## EAER calculation VH and VL

# Impacts of different $R_{CDC}$ on EAER

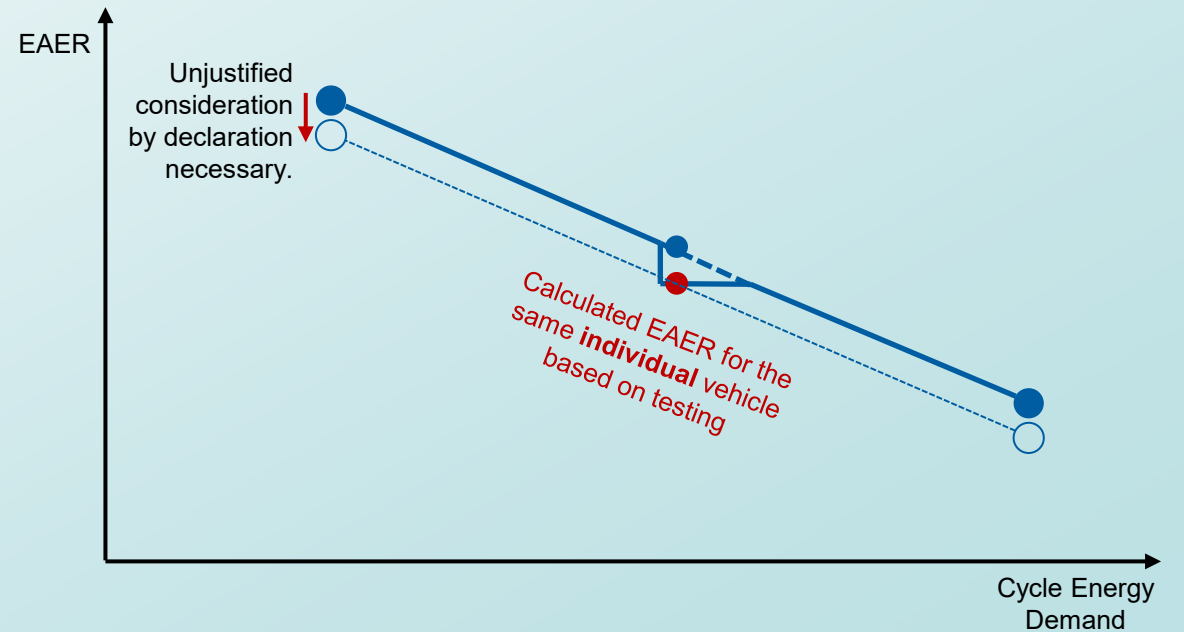
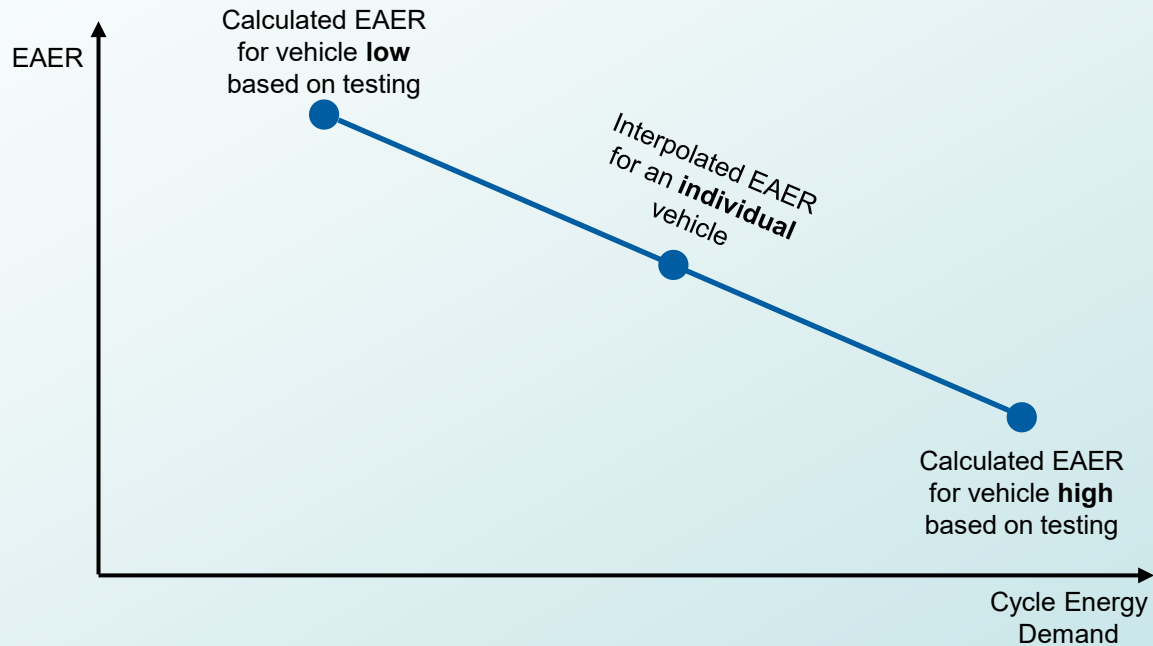
The interpolation approach assumes an linear character between low and high what is correct from a physical perspective, but...

... if an individual vehicle tested e.g. for ISC without keeping the  $R_{CDC}$  constant, there is a **non-physical-based** difference between the interpolated EAER and the calculated EAER based on a test. The only solution to cover this is to consider it with the declaration but the manufacturer should not be forced to cover methodical weak points.

→ In case of different  $R_{CDC}$ -values at homologation for VH and VL, some individual vehicles close to the break-off criterion (4% threshold) would lose EAER caused by the calculation method

→ Way forward to resolve this problem is just one  $R_{CDC}$ -value for the purpose of EAER calculation within one IP-family →  $R_{CDC}$  of vehicle L

## Action item ISC:

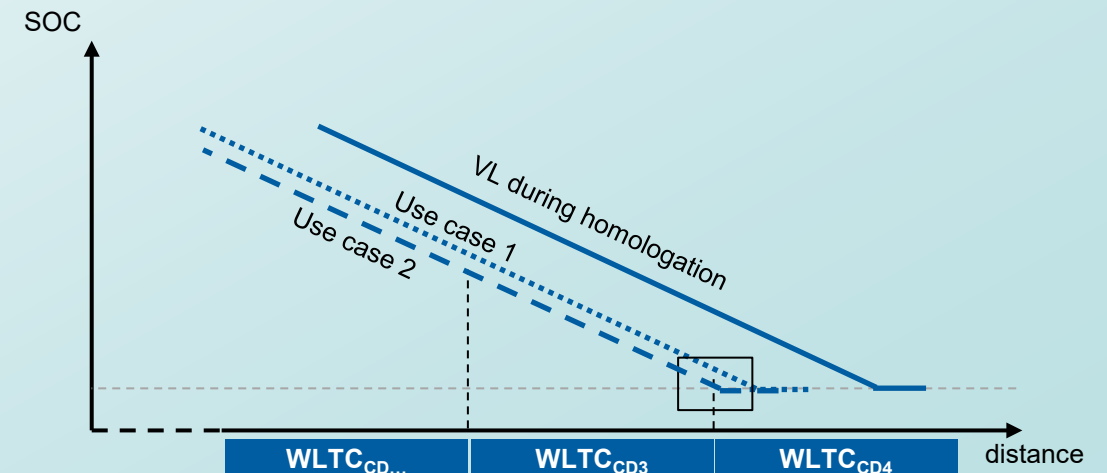
In context of an individual vehicle @ ISC (e.g. EVE-GTR) it is necessary to refer to the  $R_{CDC}$ -value determined during type approval.

→ This eliminates the impact of the break-off-criterion on  $R_{CDC}$  and therefore on EAER for ISC-testing.
